# Access Compliance Report

## Public Rights-of-Way

Intersection ID: 3901	Main Street: RHIAN_BROOK_LN	Cross Street: BEATTIES_FORD_RD	Location: SE
ADA ID: 5985A7BFBD9E	Ramp Type: Perp	Initial Pass/Fail: Fail	Overall Compliance: No
		Severity Score: 12.5

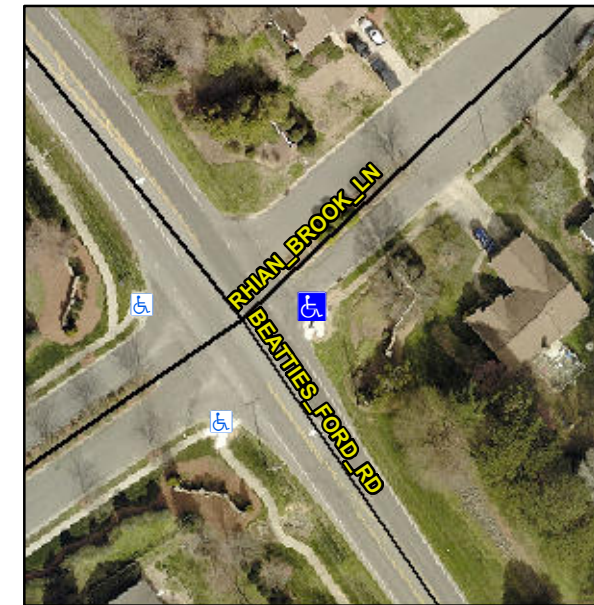
**Not Found, R304.2.2**

Compliance	Description	Data	Compliance	Description	Data
N/A	Ramp Length (in)	93.0	No	Ramp Slope (%)	11.1
Yes	Ramp Width (in)	48.0	Yes	Ramp XSlope (%)	1.4
N/A	Flare Type LT	N/A	N/A	Flare Type RT	N/A
N/A	Flare Slope LT (%)	N/A	N/A	Flare Slope RT (%)	N/A
N/A	Flare Traversable LT?	N/A	N/A	Flare Traversable RT?	N/A
N/A	Landing Length (in)	N/A	N/A	DWS Provided?	N/A
N/A	Landing Width (in)	N/A	N/A	DWS Contrast?	N/A
N/A	Landing Slope (%)	N/A	N/A	DWS Length (in)	N/A
N/A	Landing X Slope (%)	N/A	N/A	DWS Full Width?	N/A
N/A	Landing Curb? (Y/N)	N/A	N/A	DWS Offset (in)	N/A
N/A	Shared Landing?	N/A			
N/A	Gutter Ponding?	N/A	N/A	Gutter Slope (%)	N/A
N/A	Gutter Lip Ht (in)	N/A	N/A	Gutter X Slope (%)	N/A
N/A	Painted X Walk1?	No	N/A	Painted X Walk2?	N/A
	X Walk 1 Direction	To N		X Walk 2 Direction	N/A
N/A	X Walk 1 Width (in)	N/A	N/A	X Walk 2 Width (in)	N/A
	X Walk 1 Slope (%)	0.0		X Walk 2 Slope (%)	N/A
	X Walk 1 X Slope (%)	1.4		X Walk 2 X Slope (%)	N/A

**Remove & Replace Entire Ramp.**
